Product Change Notification

PCN-IFC-4260-2019

Business Unit	Product Line Code	Type of Change	Action	Date of Issue
IFC - Industrial Field Connectivity	BF2	Product Change Notification	Notify Distributors and Field	9/16/2019

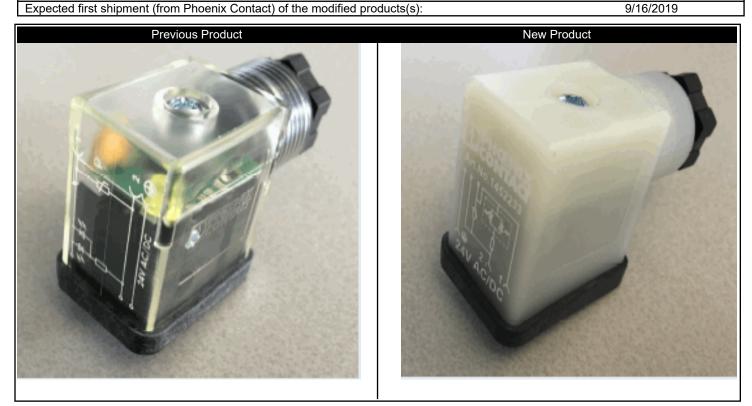
An immediate change was required for the printing on our valve connector housings, as well as a color change from transparent to white
